From: James Taylor <james.taylor@beca.com>
Sent: Friday, 27 October 2017 01:05 p.m.
To: Melissa Shipman
Cc: Peter (TMC Ltd)
Subject: RE: LUC-2017-408 - 139 Portobello Road - Tourism Activity - Clarification

From: Melissa Shipman [mailto:Melissa.Shipman@dcc.govt.nz]
Sent: Monday, 2 October 2017 11:54 a.m.
To: James Taylor <james.taylor@beca.com>
Subject: LUC-2017-408 - 139 Portobello Road - Tourism Activity - Clarification

Project: OTAGO HARBOUR GOLF CHALLENGE

Report No.: Rp 001 20171260

Figure 1: Site locality from online DCC planning maps

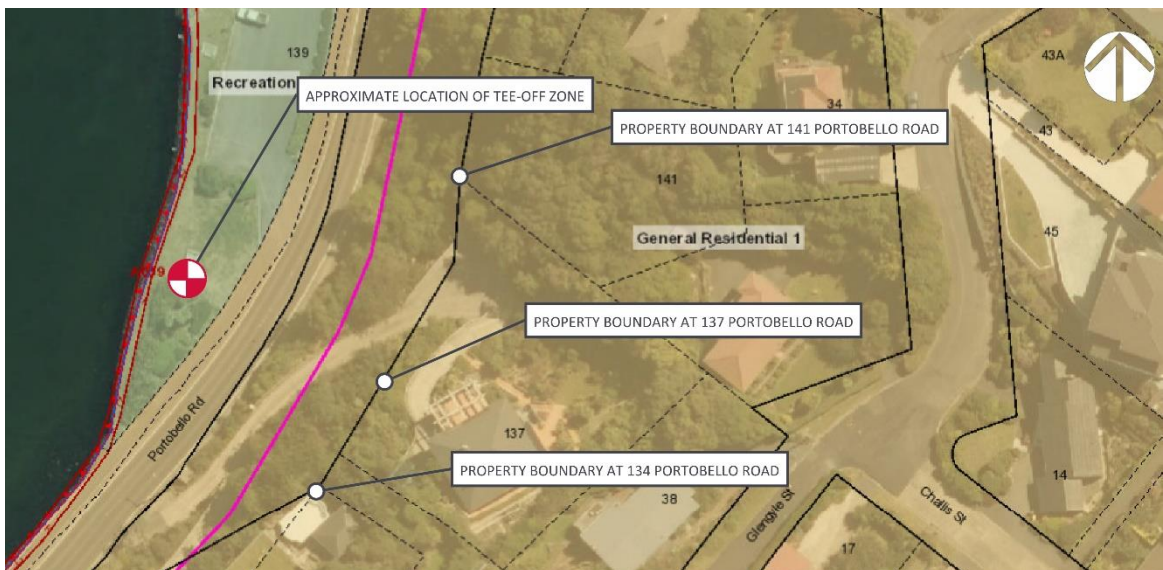
- It would be helpful to see an overlay of the golf ball striking zone ('exclusion zone') onto Figure 1 and calculate the total area m². The applicant has just indicated that this has already been provided to ORC? I have asked for a copy of the s92 response documentation. **This was in the s92 – The temporary exclusion zone is 1.06Ha. How is this part of the DCC assessment?**
